5.0 INDIVIDUAL PROTECTION REQUIREMENTS

6.0 EVALUATION OF EPA'S RESPONSES TO EEG'S COMMENTS

Fig. 15 Cumulative Net Brine In and Outflow at Fiepo.-Doubled Gas Generation rate

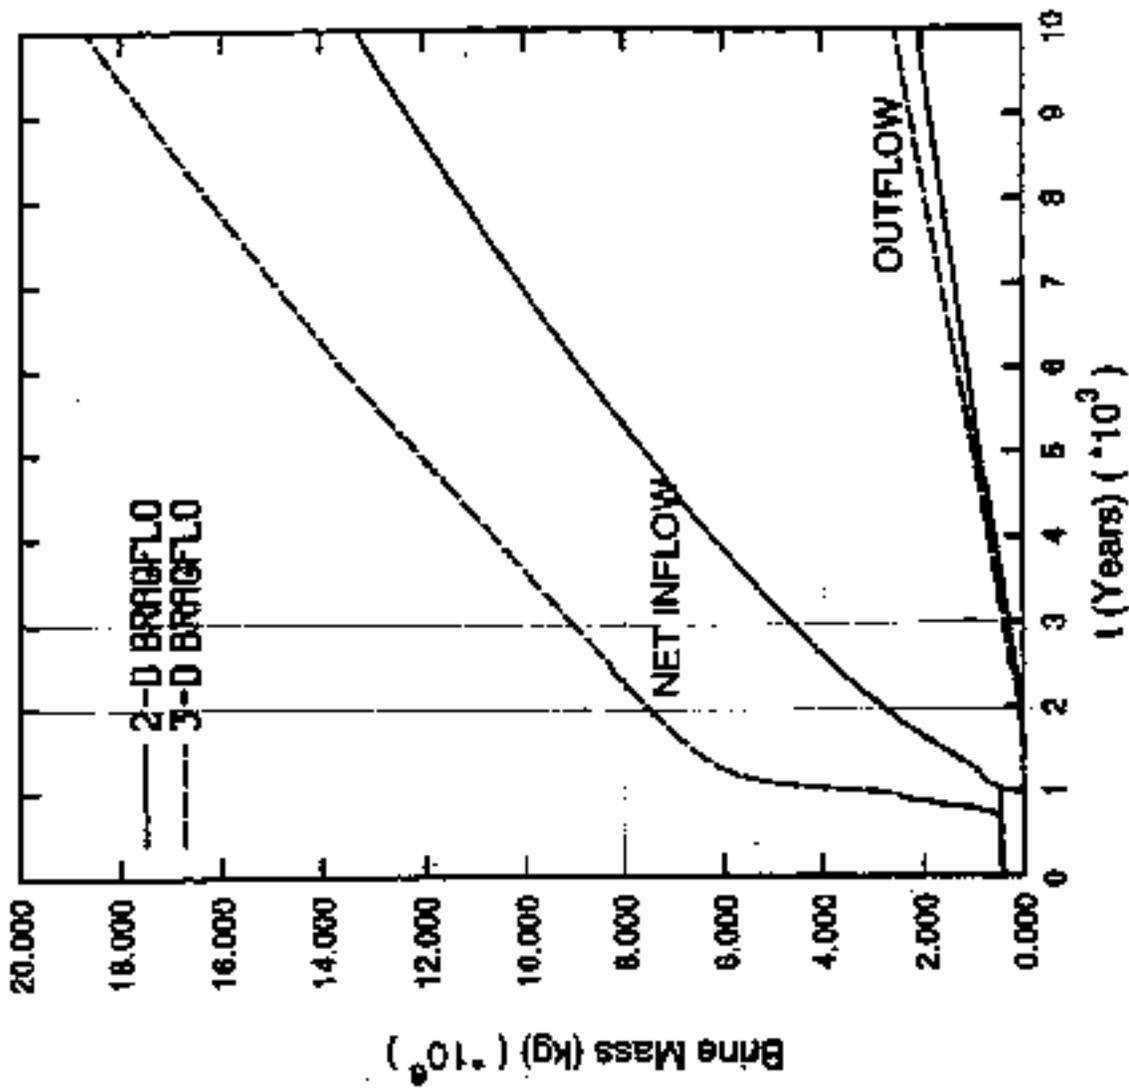
Figure 15 of the FEP S-1 analysis (Figure 2) shows the cumulative brine inflow to the repository for the high gas generation calculations. The flows calculated using the 3-D model indicate that once anhydrite bed fracturing occurs, roughly 2×10^6 kg ($1,600 \text{ m}^3$) of brine enters the repository in a period of 200 to 300 years and that this flow rate was continuing unabated at the time of drilling intrusion. Another 4×10^6 kg ($3,200 \text{ m}^3$) flowed into the repository shortly after the drilling intrusion. Figure 2 shows differences of 4×10^6 to 6×10^6 kg ($3,200$ to $6,500 \text{ m}^3$) for much of the 10,000 years. The brine inflow differences listed above should be doubled for the full repository. Virtually no flow enters the repository as a result of anhydrite bed fracturing in the 2-D geometry. In fact, the net flow over the 10,000 year simulation is less with anhydrite fracturing compared with the simulation without the beds fracturing. Figure 2.1.4 of the sensitivity analysis report² (Figure 3) indicates very little marker bed inflow with microbial gas generation of plastics and rubber, supporting the findings of the FEPs analysis. Figure 5.1.5 of the sensitivity analysis report reveals the importance to direct brine release of these low brine inflows. The highest pressures are correlated with brine saturations below the residual brine saturation of the waste. The low saturations are due partly to increasing repository pore space with increasing pressure and partly to lower brine inflow.

Fig. 10 Cumulative Net Brine In and Outflow at Repo. - Base Gas Generation rate

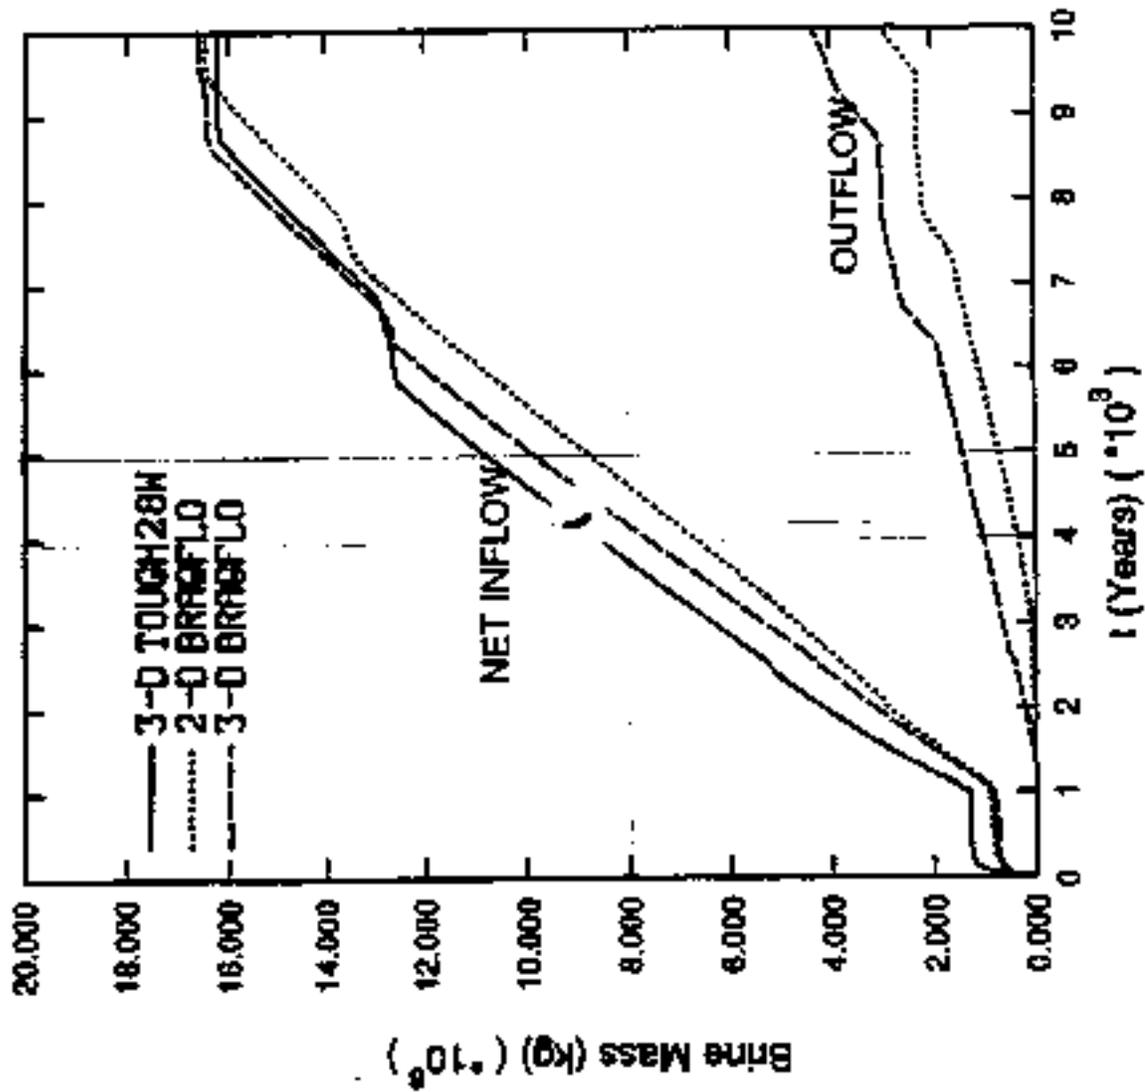
The simulations without anhydrite fracturing show a decrease of 1×10^6 to 2×10^6 kg (800 to $1,600 \text{ m}^3$) in predicted brine inflow in the 2-D simulations compared to the 3-D simulations (Figure 4; Figure 10 of the FEP S-1 memo). These flows are doubled for the full repository. The differences are most likely from differences in marker beds flows to the repository.

Figure 1. Lease grade potash ore² and oil and gas wells.³

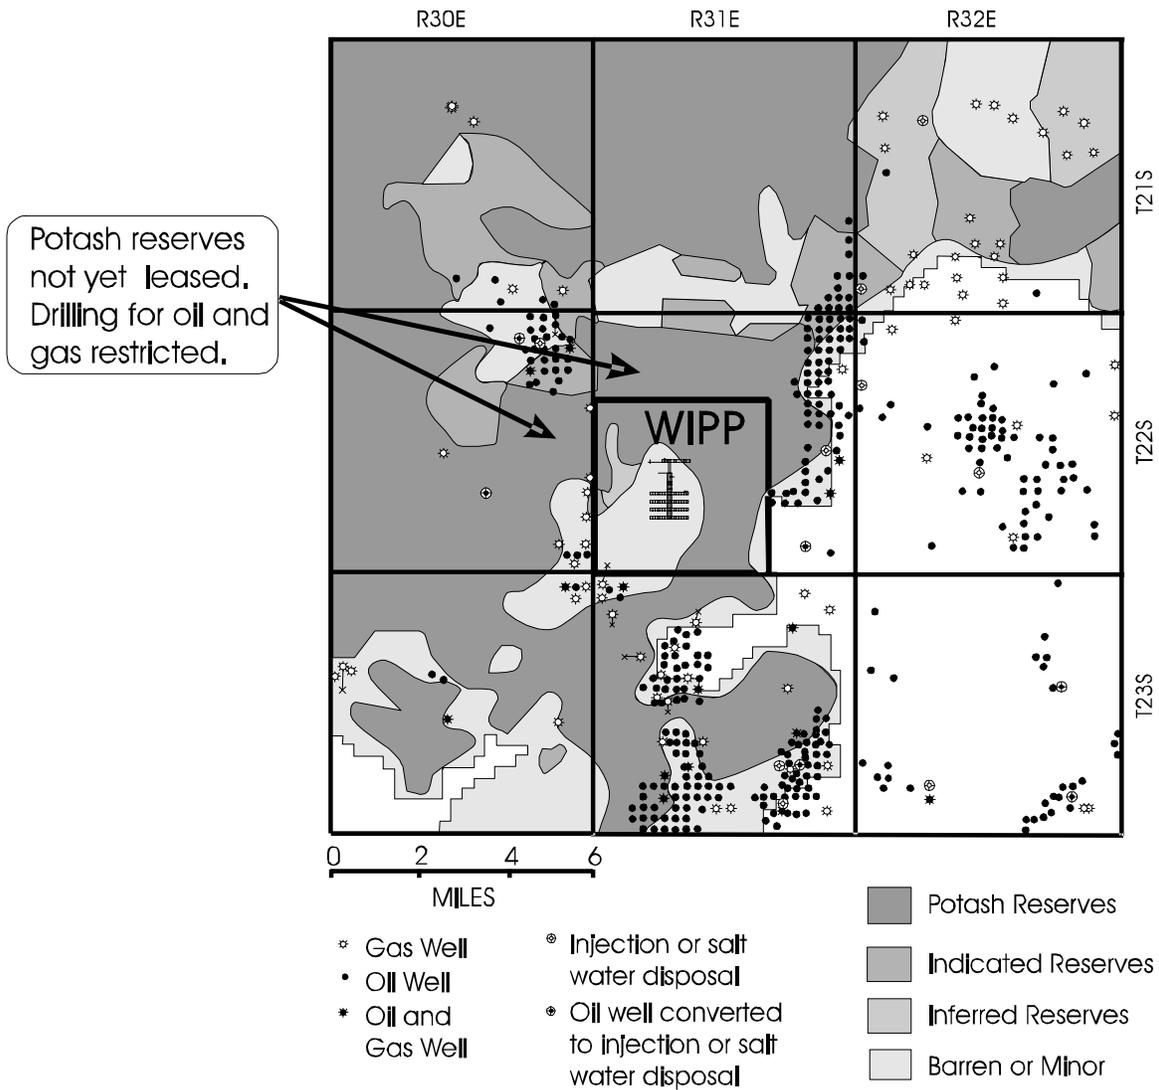
For illustrative purposes, Figure 1 identifies one area of known potash reserves adjacent to the northwest boundary of the WIPP Site. Figure 2 indicates that these potash reserves have not been leased. Potash operators are allowed to hold, directly or indirectly, no more than 51,200 acres in potash permits and leases in a state (43 CFR 3530.3). An operator may not hold all the potash leases he intends to develop (Ref.4, p. 11).

Figure 3. Minnable potash.

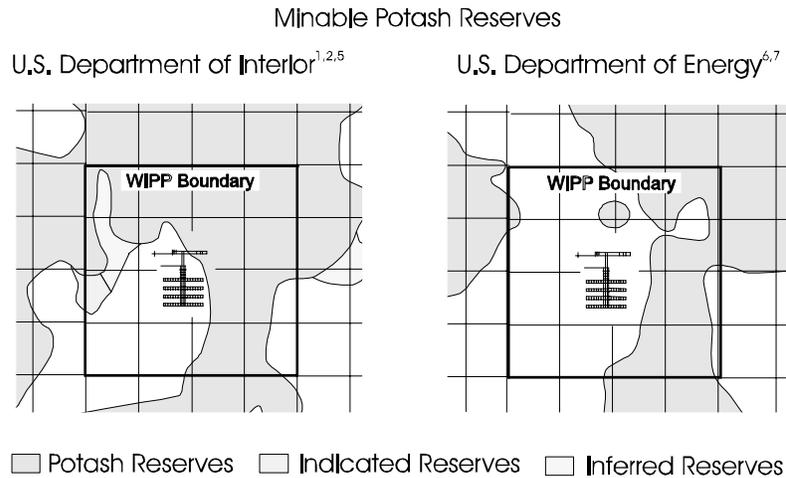
Figure 3 shows the different estimates by DOE and DOI of the extent of minnable potash within the WIPP site.

Figure 4. Potash leases within the Delaware Basin and minable potash not yet leased.

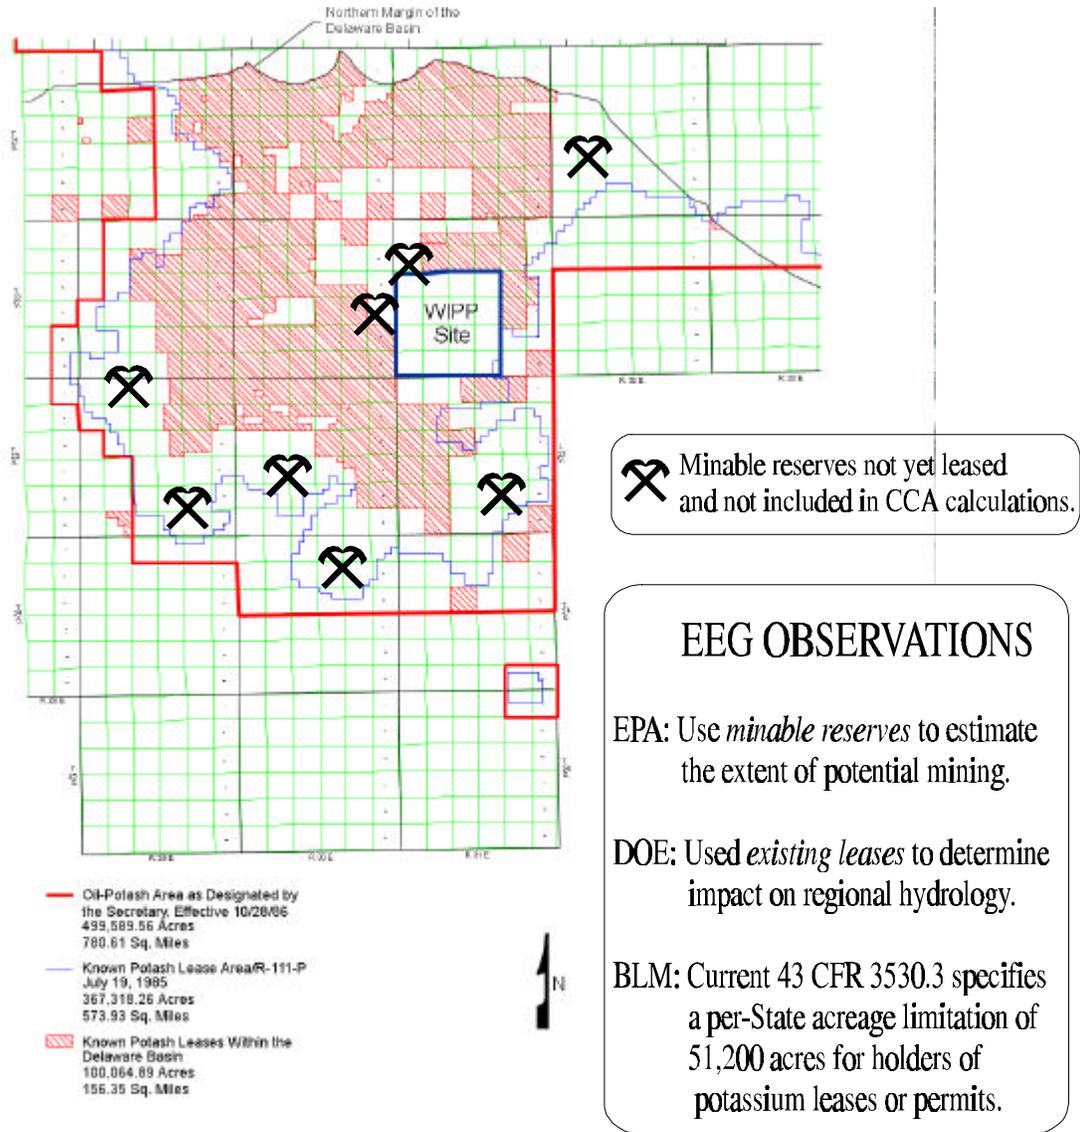
As shown in Figure 4, the CCA does not include the impact of potash mining in unleased areas which will also affect the regional hydrology. 40 CFR Part 194.32 states:
